STATE OF CONNECTICUT  
CONNECTICUT SITING COUNCIL

DOCKET NO. 506

**RESPONSES OF NEW CINGULAR WIRELESS PCS, LLC (AT&T) TO  
CONNECTICUT SITING COUNCIL PRE-HEARING INTERROGATORIES, SET ONE**

SHEET NUMBER  
**C-1**

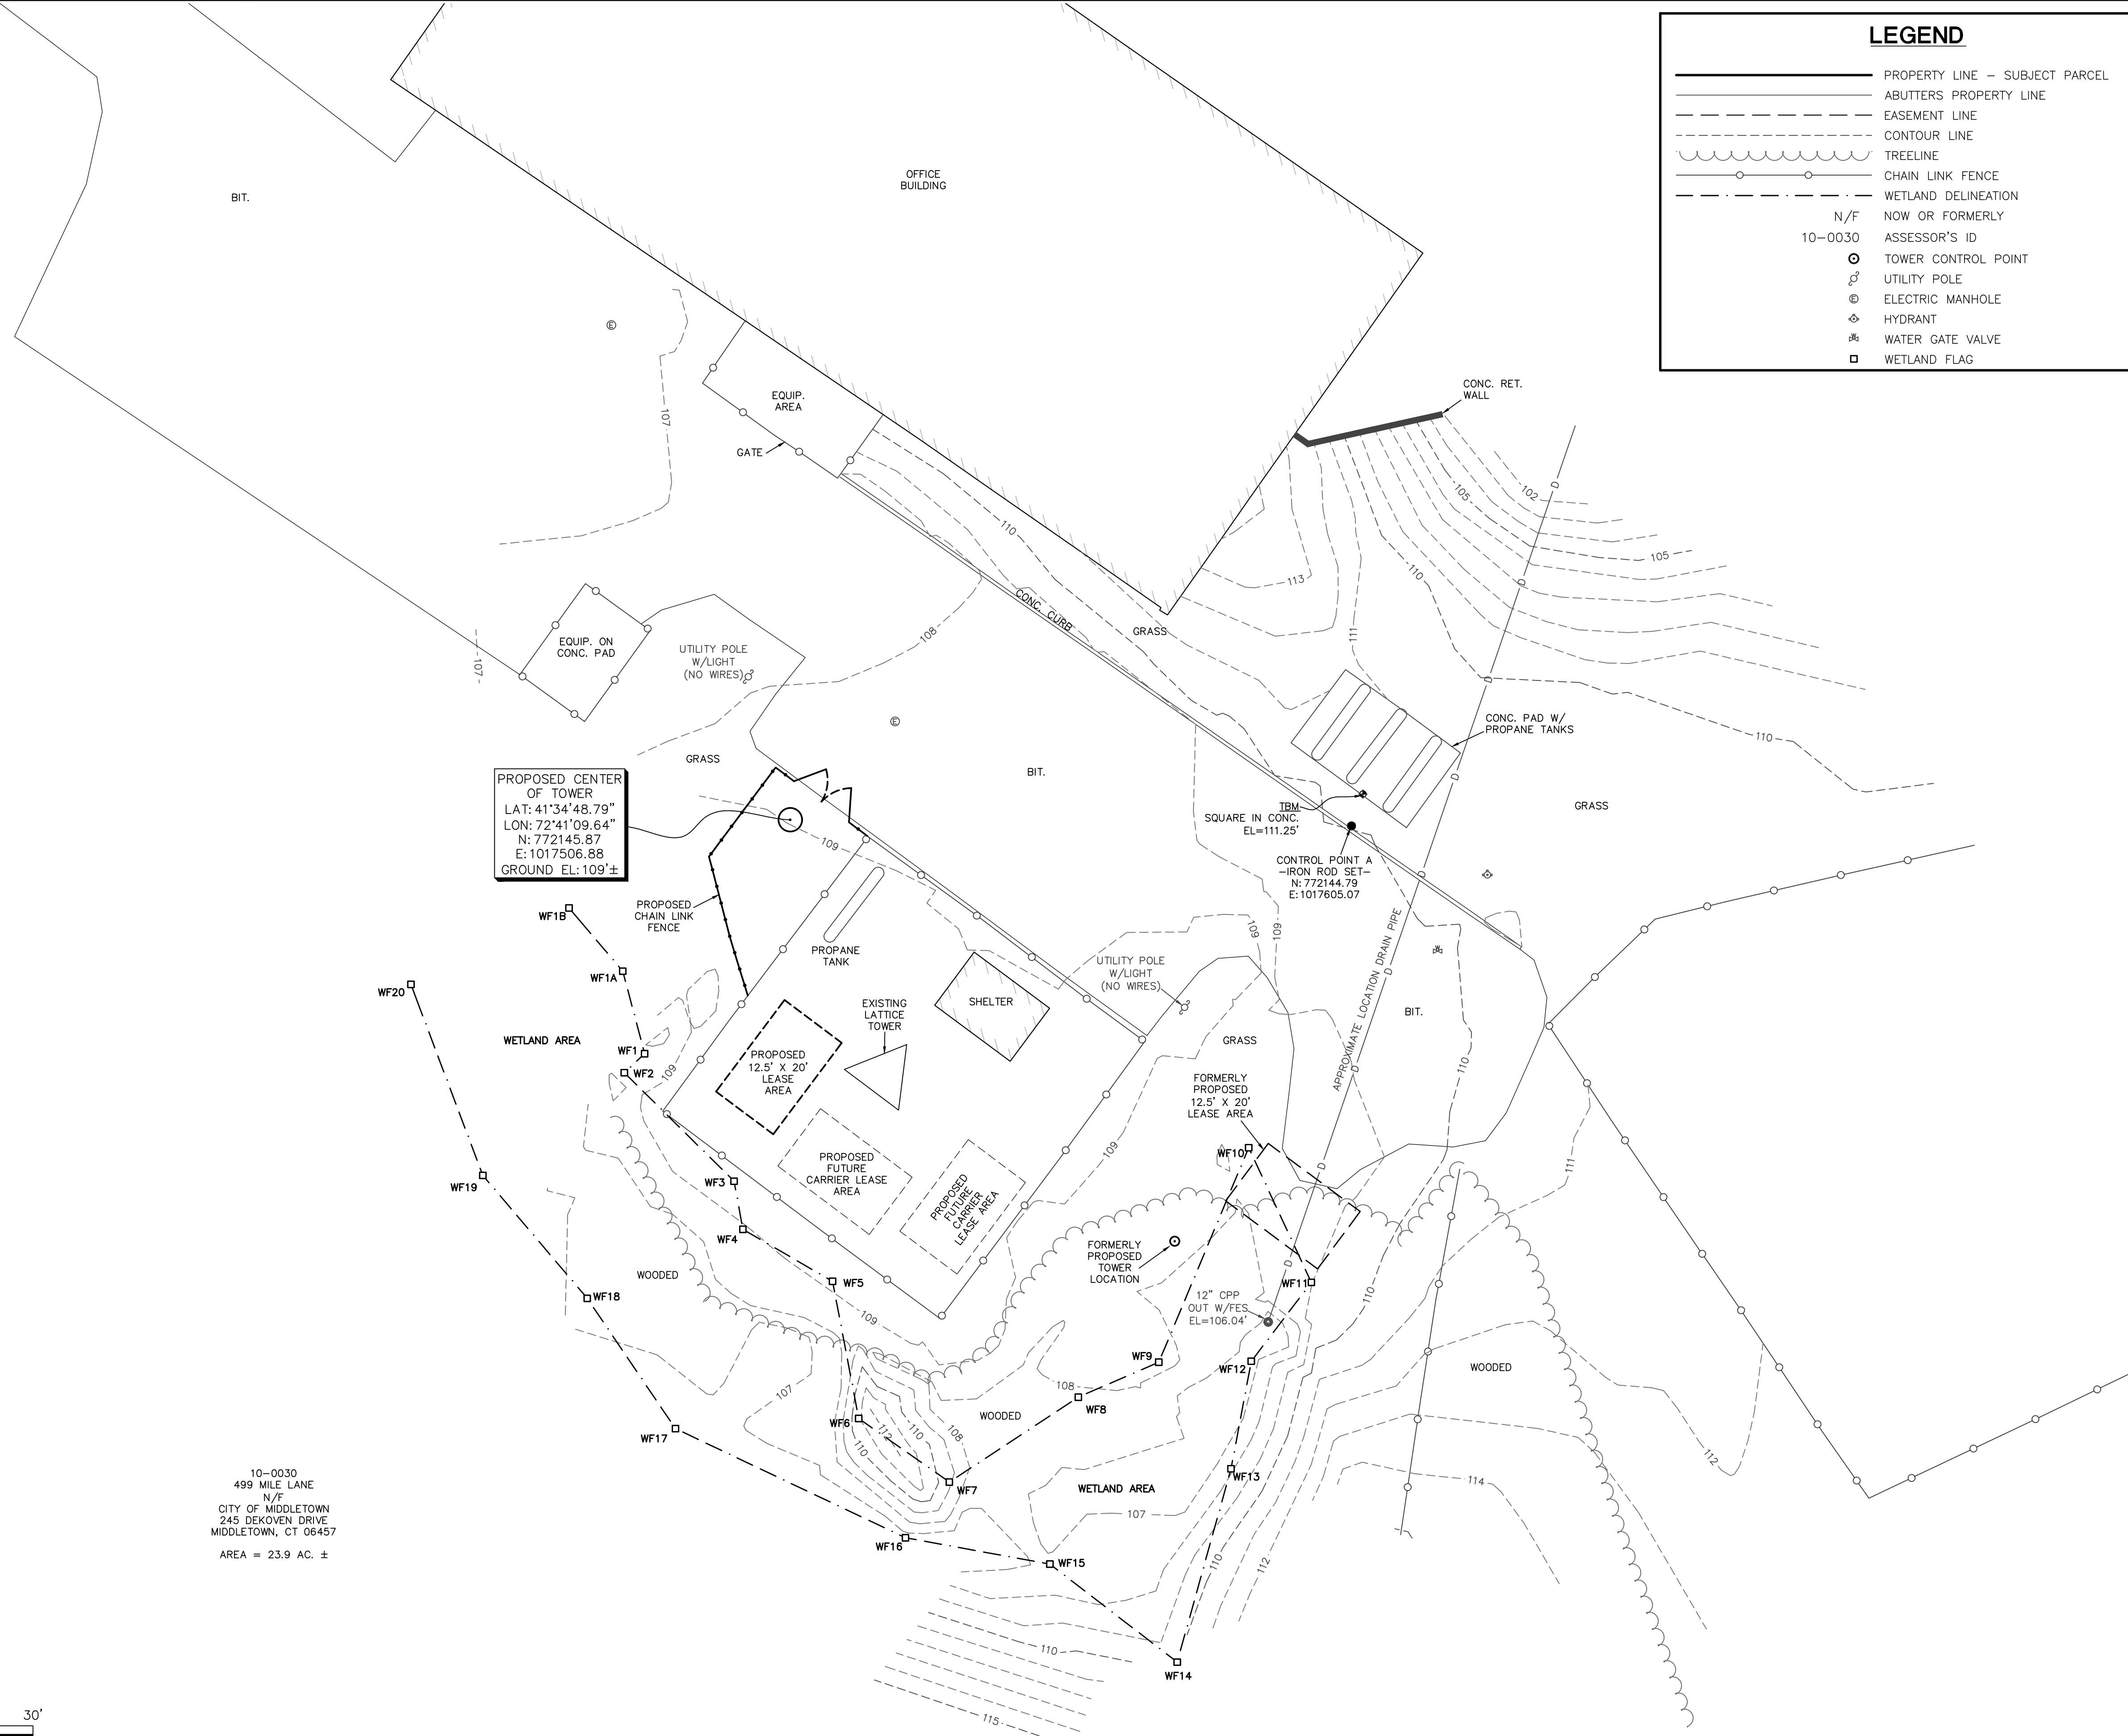
- Q2. Referencing Attachment 3 of the Application, Sheet C-1, New Cingular Wireless PCS, LLC's (Applicant or AT&T) Plot Plan appears to indicate the site parcel is zoned NPD rather than R-15 (Residential) as noted in the Zoning Information box. Please clarify.

Q25. Referencing Attachment 3 of the Application, Drawing C-1, provide the distance from the center of the proposed 150-foot monopole to the nearest property line. If this distance is less than 150 feet, could the tower be designed with a yield point to ensure that the tower setback radius remains within the boundaries of the subject property? What would be the cost of installing such yield point?

- A2. *The site parcel is classified within the R-15 residential zone.*
- Q3. Estimate the total cost of the proposed project. Break down the total cost into categories that AT&T deems appropriate.

A25. *The distance from the center of the proposed monopole, in a revised location, to the nearest property line is approximately 256 feet. A 1 x 150' tower setback will be maintained within the boundaries of the subject property and therefore no yield point will be required. Included in Attachment 7 are updated site drawings, prepared by Hudson Design Group LLC, revised through November 22, 2021, which have been amended to reflect a revised second tower location and equipment in the existing tower compound to address the results of field reconnaissance and survey work completed post filing and partially in response to Interrogatory Question No. 72. These minor changes in location and equipment layout are described in more detail in the response to Interrogatory Question No. 66 herein and reduce the area of land proposed for disturbance principally to that of the second tower location. The amended site drawings include a full survey on Sheet C-1 with setback distances identified and it is noted that the*

*site drawings previously submitted with the Application were based on plot plan with shorter distances identified than those noted on the survey.*

AT&T		
ELEVATION AND ANTENNA PLAN (NSB)		
SITE NUMBER	DRAWING NUMBER	REV
CT3470A	A-2	3

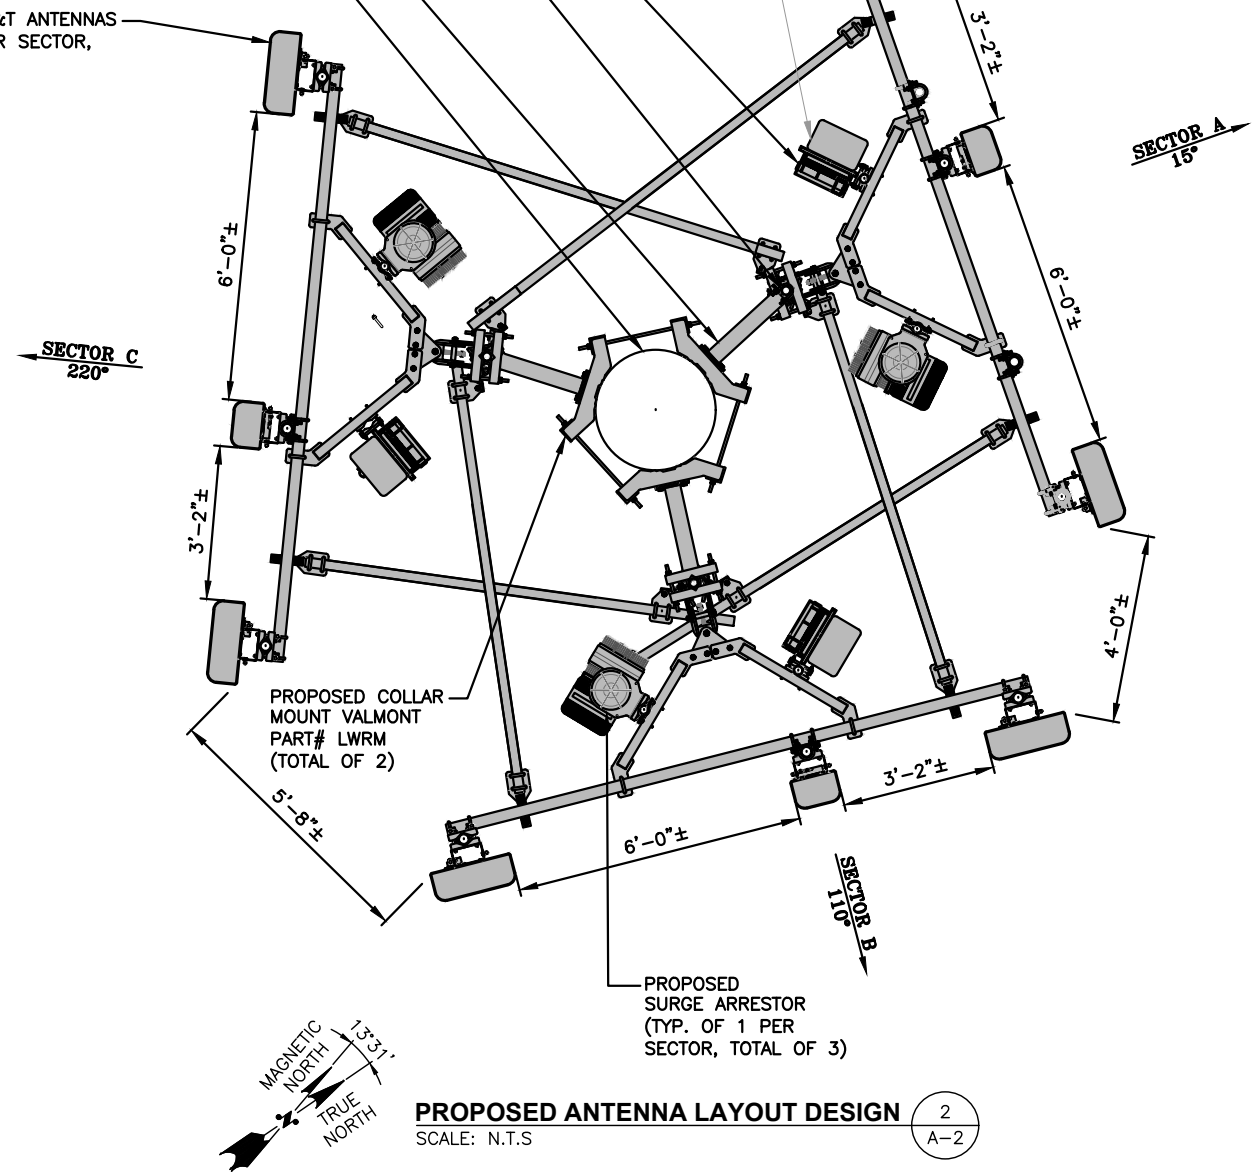
Q29. Referencing Attachment 3 of the Application, Drawing A-2, Proposed Antenna Layout Design, is AT&T seeking approval of the "Future AT&T RRH's" as part of this project, or would AT&T seek such approval in the future? Are the future RRH's factored into the structural and mount analyses?

*A29. AT&T is not seeking approval of future RRH's at this time and would file notices of exempt modifications at a later date. The future RRH's were factored into the structural and mount analyses.*
